Ref: RML2420

From: ABPmer on behalf of ABP

Subject: Response to comments from Natural Resources Wales in relation to the Future Port Talbot Ground Investigations Marine Licence Application (RML2420)

Figure 1: Location of Ground Investigation sampling stations in relation to Section 7 habitats.

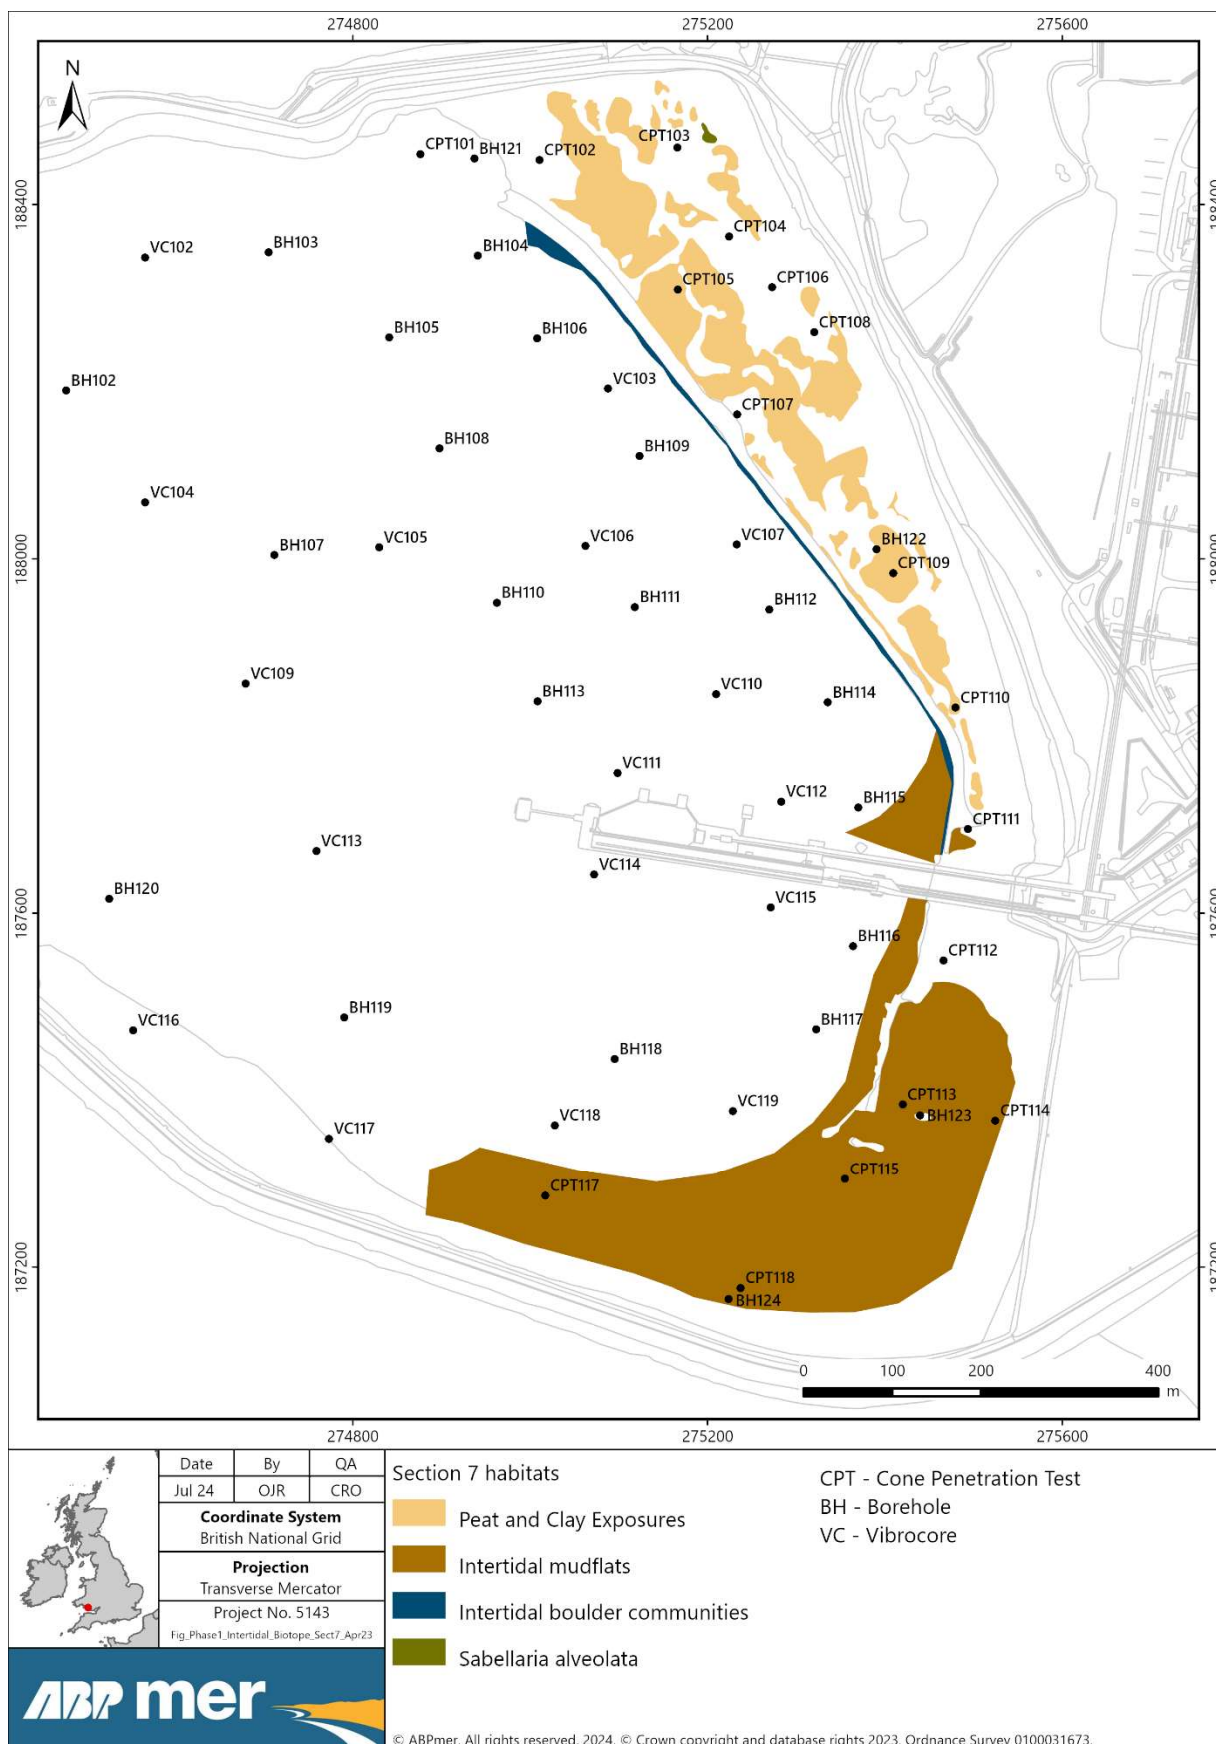
- *As such, NRW (A) requests further information and clarification on the sampling methodology and proposed development which should be updated and submitted to NRW prior to works commencing in order to understand the numbers of boreholes and/or CPT [Cone Penetration Tests] proposed on the exposed peat and clay habitats, the necessity for directly sampling on this Section 7 habitat, and the different methods proposed for different habitats i.e. will a jack-up barge be used for boreholes on each intertidal habitat?*

- *Until further justification is provided as to the requirement to directly sample peat and clay exposures in this instance, NRW (A) strongly advises that the ground investigation works avoid this Section 7 habitat and implement a buffer zone around any peat and clay exposures to minimise any impacts from the vehicles/machinery used in these ground investigations, particularly those related to the jack-up barge operating in the intertidal area.*

A meeting was held between the engineering team and environmental specialists to review the planned locations for the boreholes and CPTs in relation to the mapped² Section 7 habitats. Each sample station was considered individually to determine whether it was essential to sample in that location, or whether it could be relocated. Tidal constraints to sample site locations were also taken into consideration. Through this review process, it was possible to relocate four sample stations outside the mapped extent of the peat and clay habitat. There is one remaining borehole (BH122) and three CPT sampling stations (CPT105, CPT109 and CPT110) which were deemed essential to sample as a minimum to inform the design.

The locations of boreholes and CPTs are shown in Figure 1. The numbers of sample stations in each Section 7 habitat and the combined footprints of the jack-up barge, boreholes and CPTs are provided in Table 2.

It is acknowledged that for a small number of sample stations it is the intention to acquire one sample per station within the Section 7 peat and clay exposures habitat (1 borehole and 3 CPT stations, see Figure 1 and Table 2). It is understood that multiple samples could not be taken in the same location or within 20m of that location.
